Planning Objection

51 The Fieldings, Southwater, RH13 9LY

Application reference DC/26/0197

The current application follows the recent refusal of DC/2025/1400 and proposes a two-storey 3 bed replacement dwelling with three parking spaces.

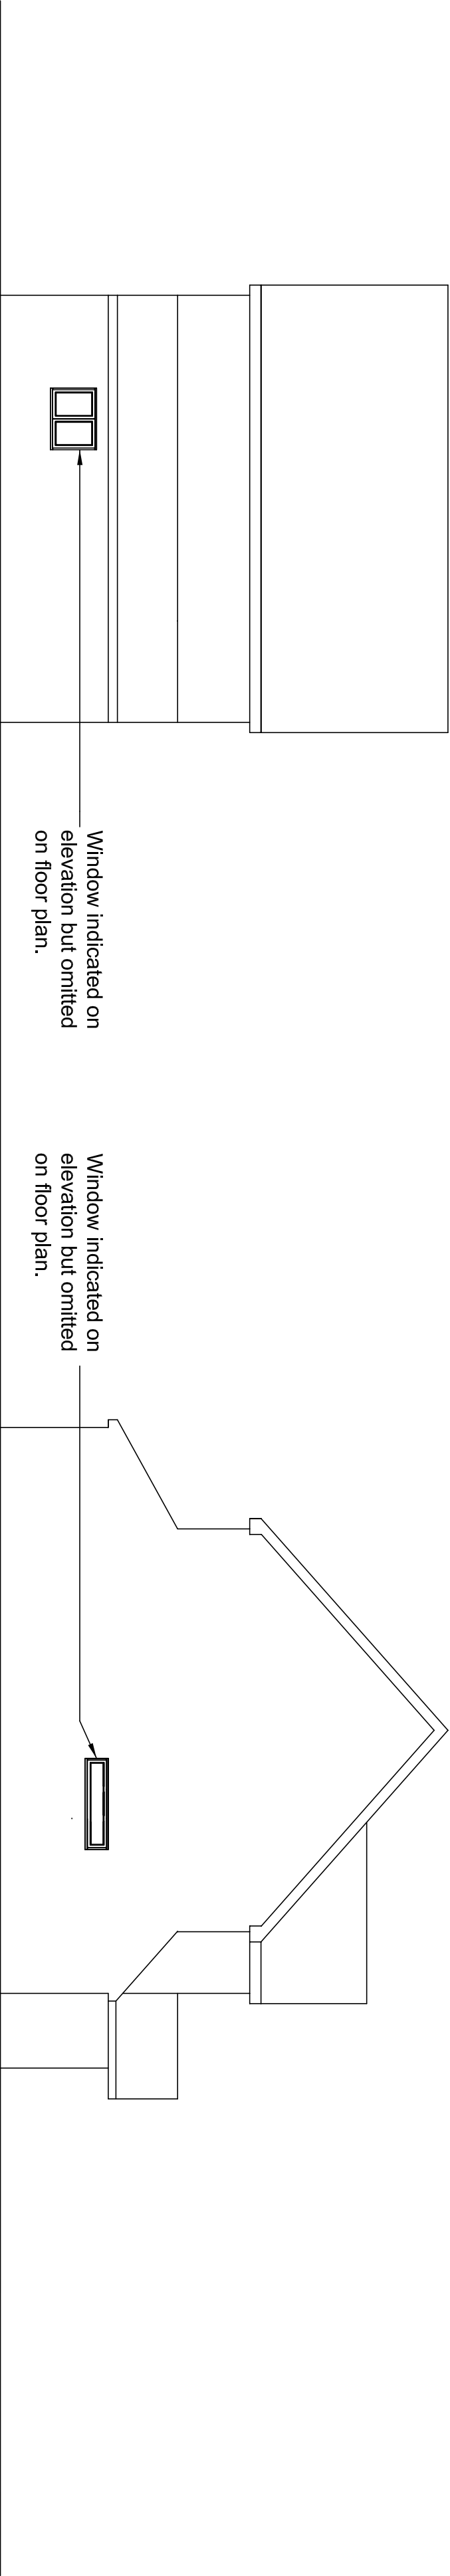
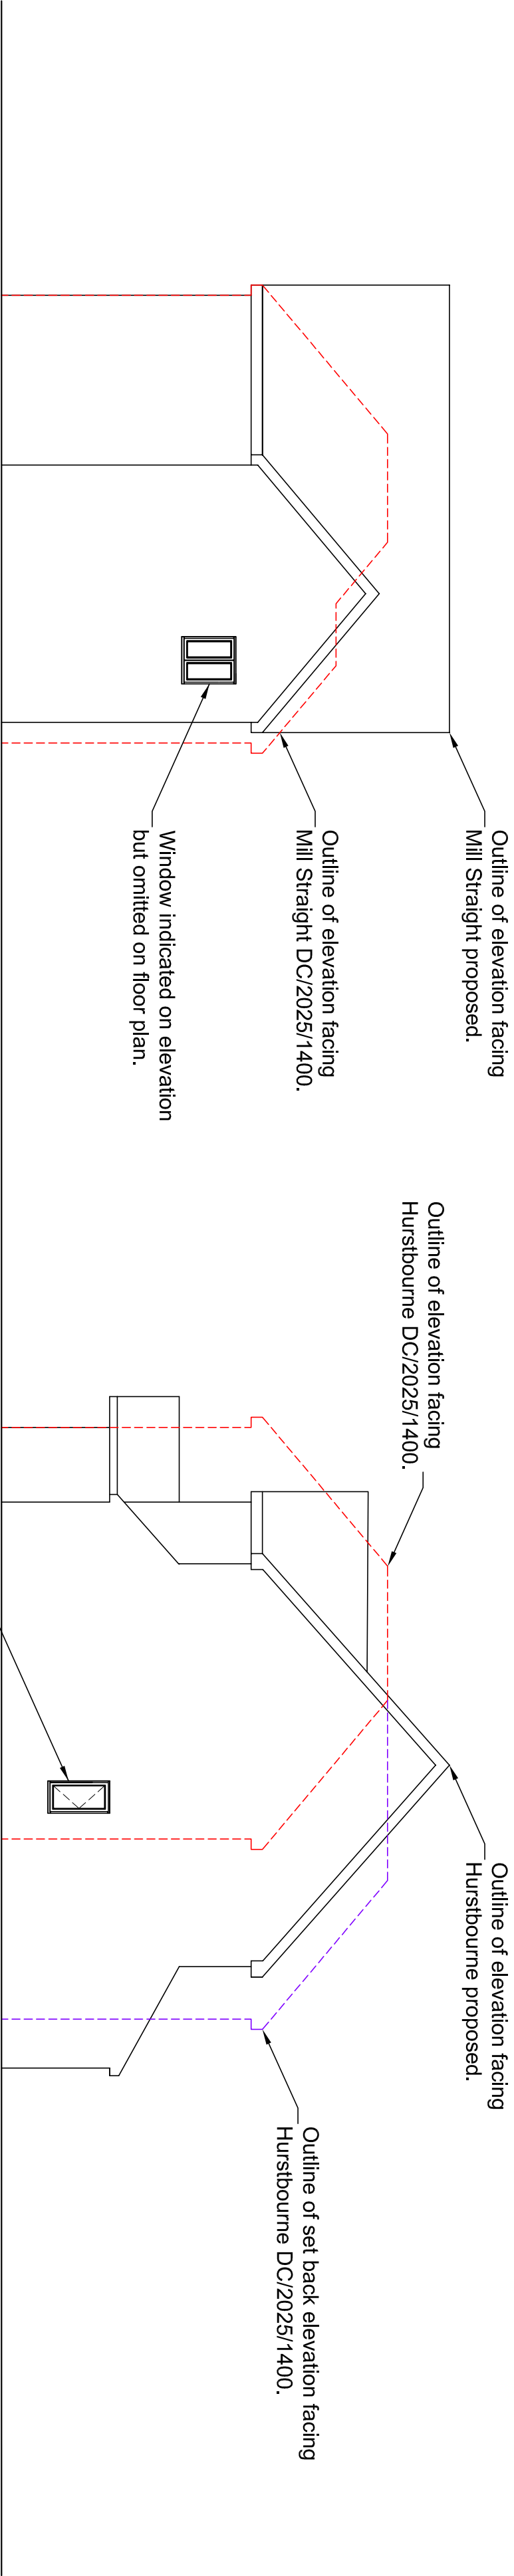
However, the current proposals propose a dwelling that is 1.2m higher than the previously refused dwelling. Additionally, the previous dwelling had a fully hipped roof whereas the current proposals have gable walls to the south-west and north-east elevation. Both of these design factors materially increase the impact of the proposals on the adjoining dwellings. This is clearly demonstrated by our drawing 26.06.02 which compares the current scheme with the previous application DC/2025/1400 and which clearly demonstrates the increased impact.

The proposals are for the same floor area but with an increased height and replacement of hipped roofs with gables so therefore the impact is increased on adjoining properties.

Site Lines

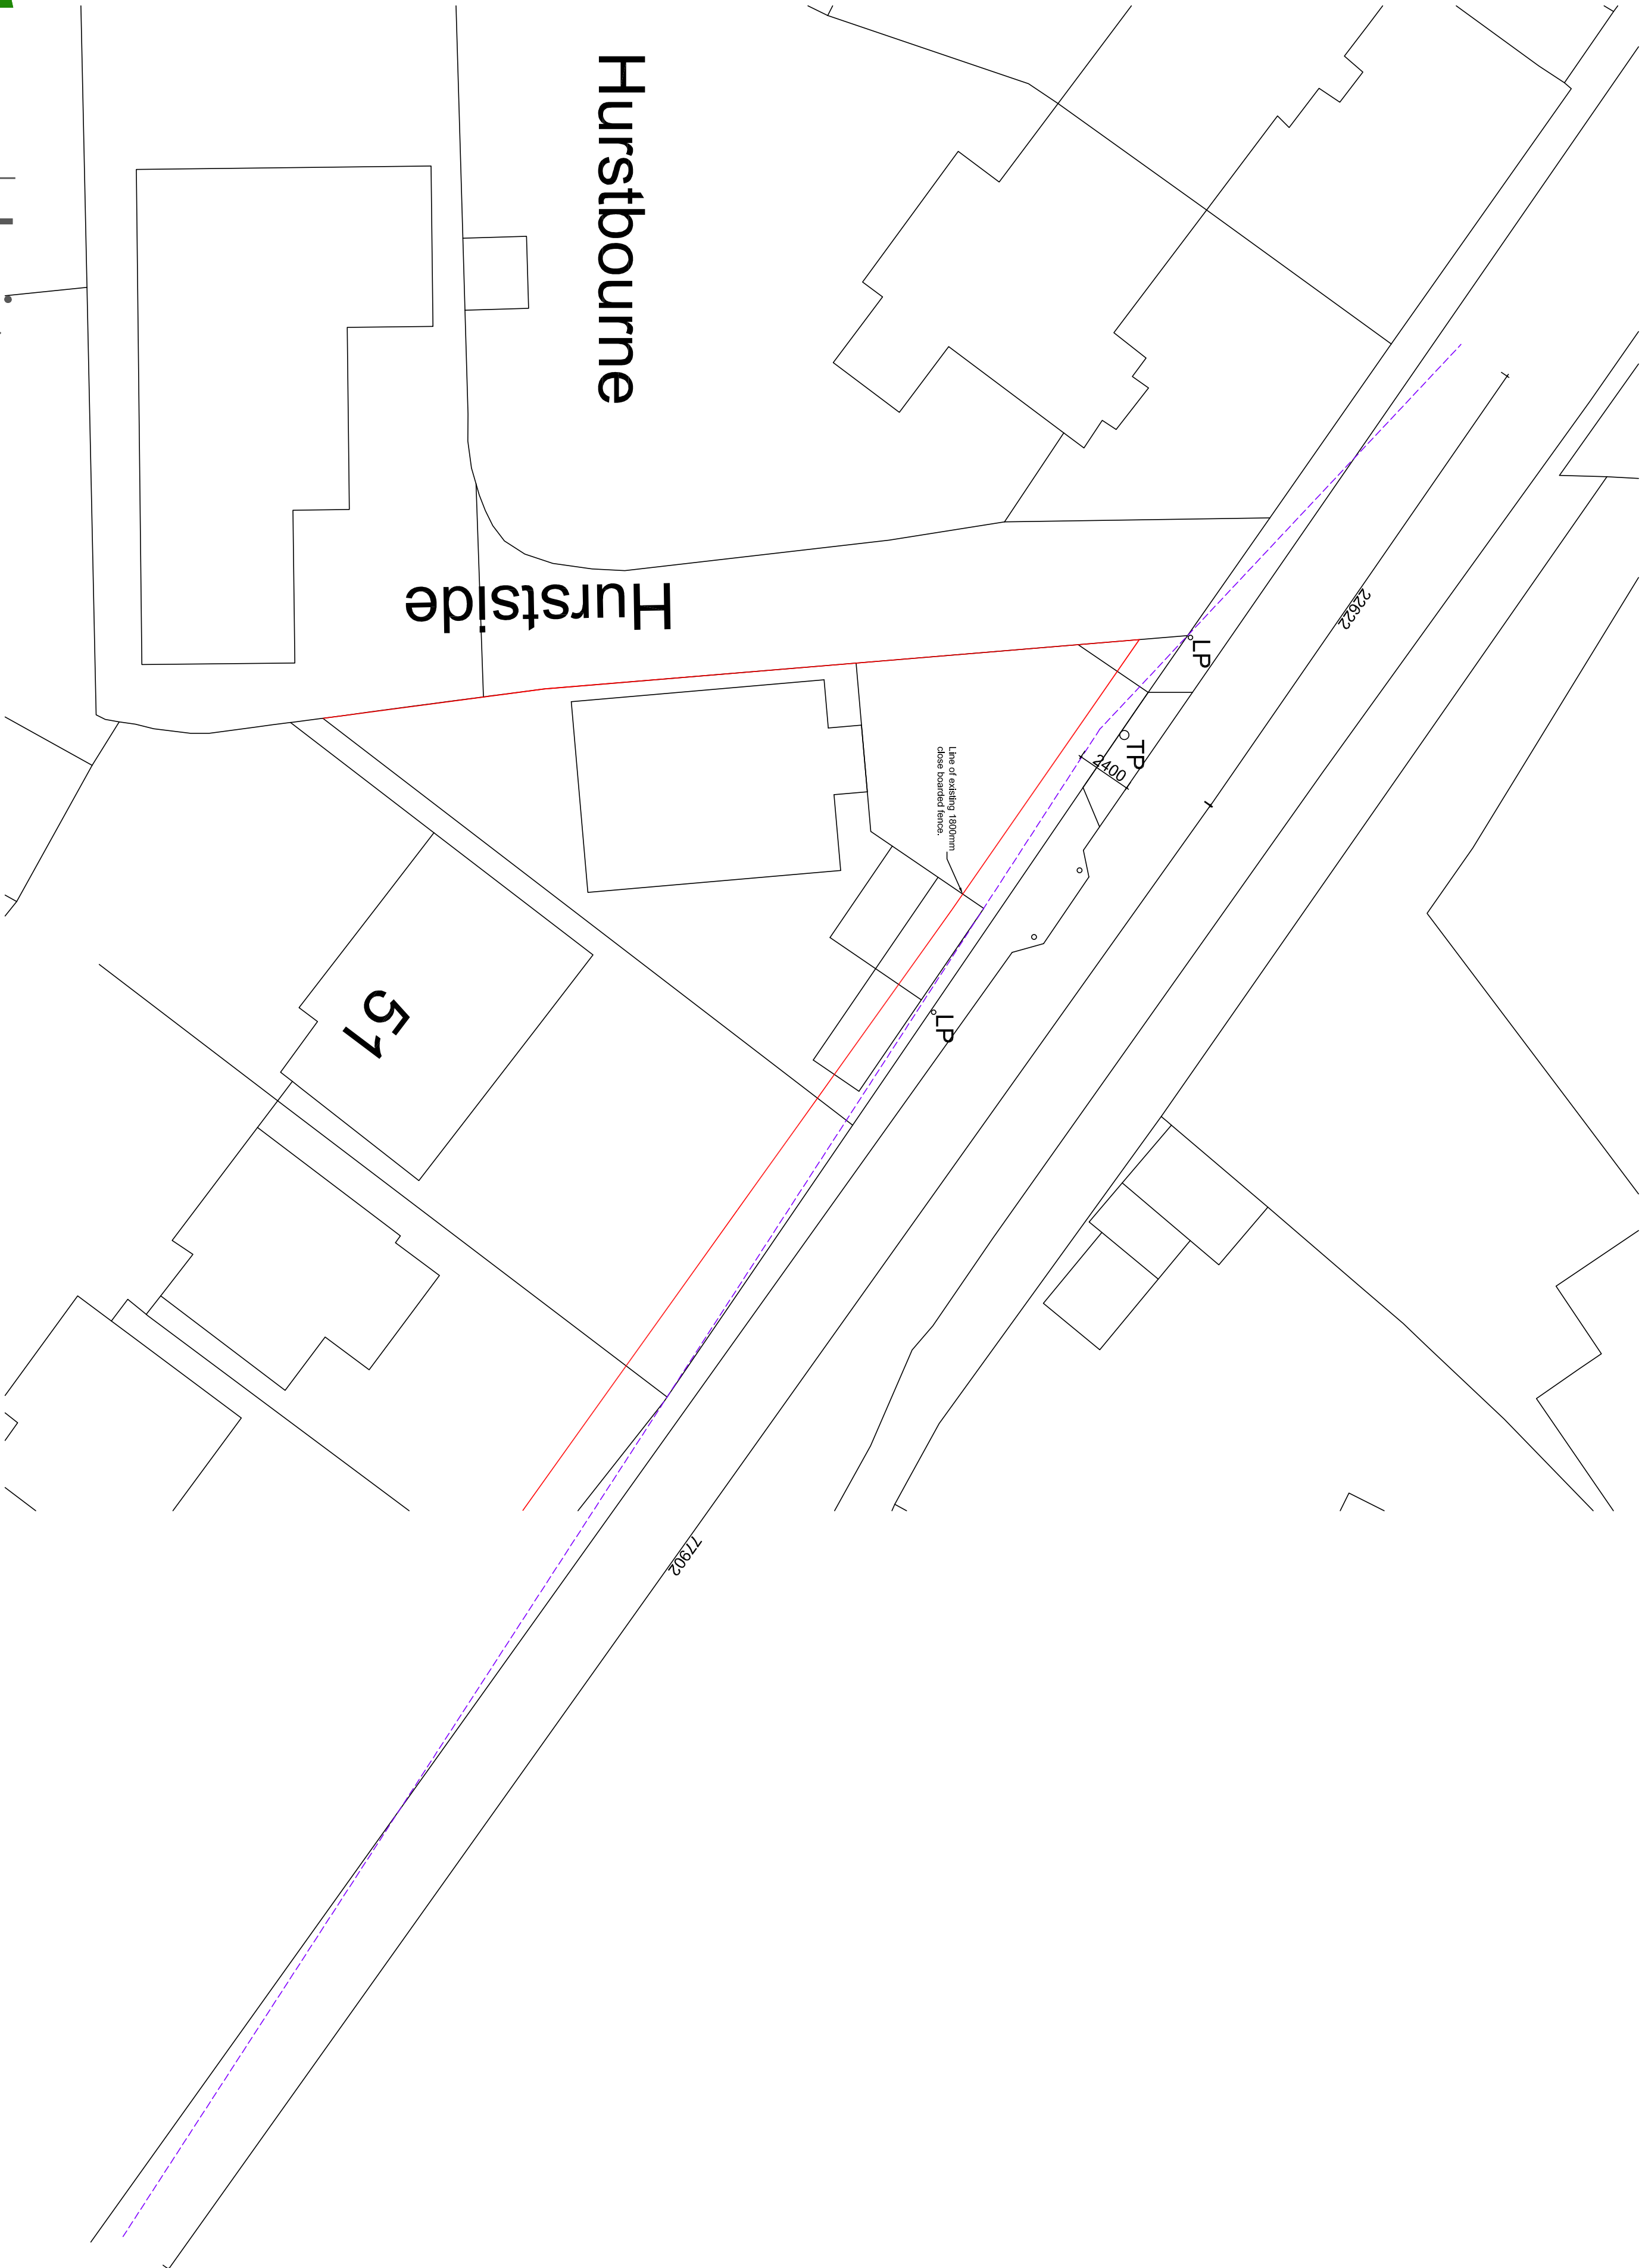
As neither of the applications have bothered to adhere to the requests of WSCH we have attached a copy of our drawing 26.06.03 which details the site lines achievable on the site. This demonstrates that to the south-east only 77 metres can be achieved (even utilising the full extent of the plot of 51 The Fieldings which is in excess of the criteria utilised on the submission drawing 195/2025/5) and only 22.6m to the northwest. Both site lines are woefully short of the required 120 metres which is presumably why the requests from WSCH and HDC were ignored.

These site lines are also well short of the 90 metres required for a 30mph speed limit which the application incorrectly stated in DC/2025/1400 was applicable to Mill Straight instead of the 40mph speed limit confirmed by WSCH.

When the criteria used on the submitted drawing 195/2025/5 are utilised, the site line to the south-east reduces to 31.8 metres.

- The telegraph pole fouls the vehicular access.
- The parking indicated requires relocating/removing the boundary fence, infilling the ditch and removing the existing planting to the back edge of the footpath.
- Relocating the fence would compromise the existing vehicular access to Hurstbourne and Hurstside.
- Turning within the site is cramped and requires several manoeuvres and may still result in vehicles reversing onto Mill Straight.
- The requirements for the site lines have still not been addressed and cannot be achieved as clearly indicated on our drawing 26.06.03.
